## **G Emergency Response Facilities**

#### G.4 Emergency Operations Facility

**Figure G-4 ~~Site Layout And Evacuation Routes~~**  
**Location of Emergency Operations Facility Relative to**  
**South Texas Project Site**

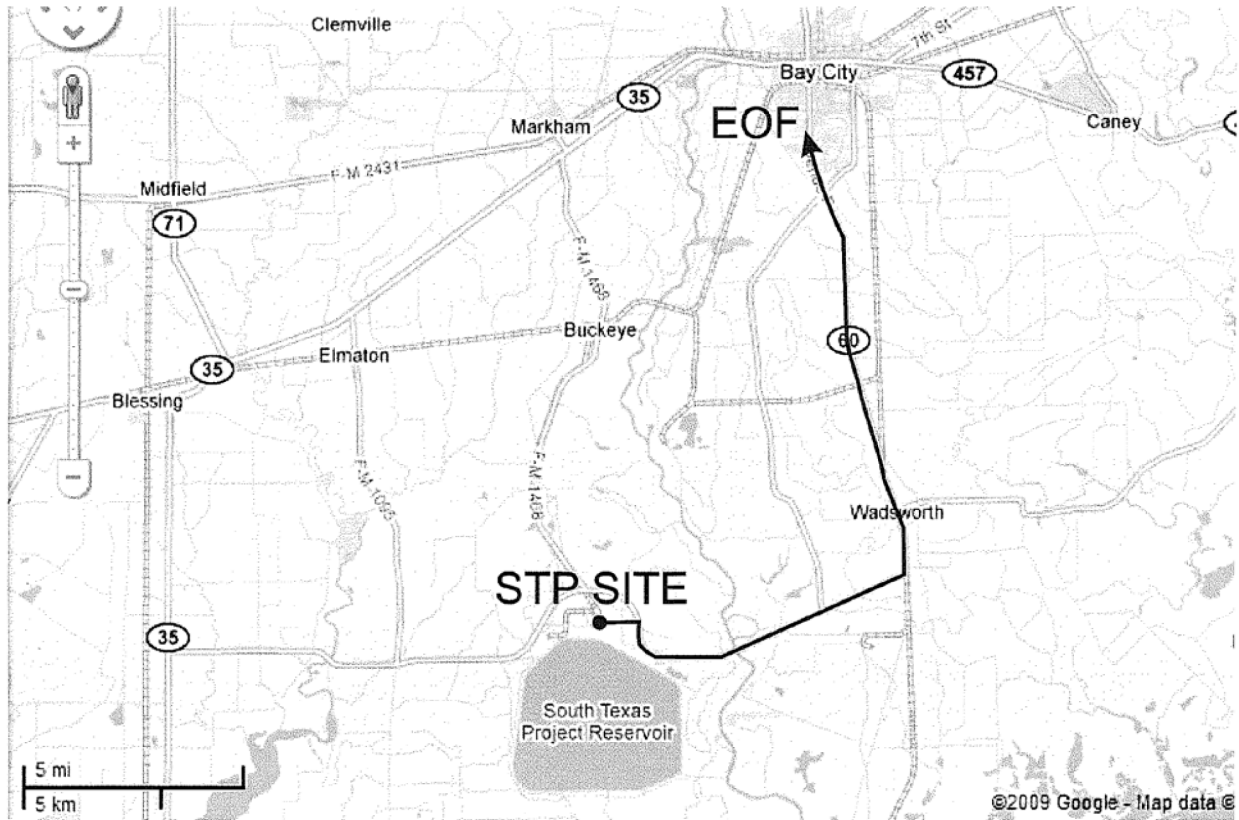
~~The Emergency Operations Facility is located approximately one-half mile East of the center line of Unit One, adjacent and connected to the Nuclear Training Facility. The location of the Emergency Operations Facility and evacuation routes from the Facility are defined on Figure G-4. The floor plan of the Emergency Operations Facility is depicted on Figure G-5. When activated, the Emergency Operations Facility also serves as the primary location for the following typical functions:~~

The Emergency Operations Facility is located in Bay City, Texas at 4000 Avenue F, approximately 12.5 air miles north-northeast of the Station. Figure G-4 depicts the location compared to the site. The floor plan of the Emergency Operations Facility is depicted on Figure G-5. When activated, the Emergency Operations Facility serves as the primary location for the following typical functions:
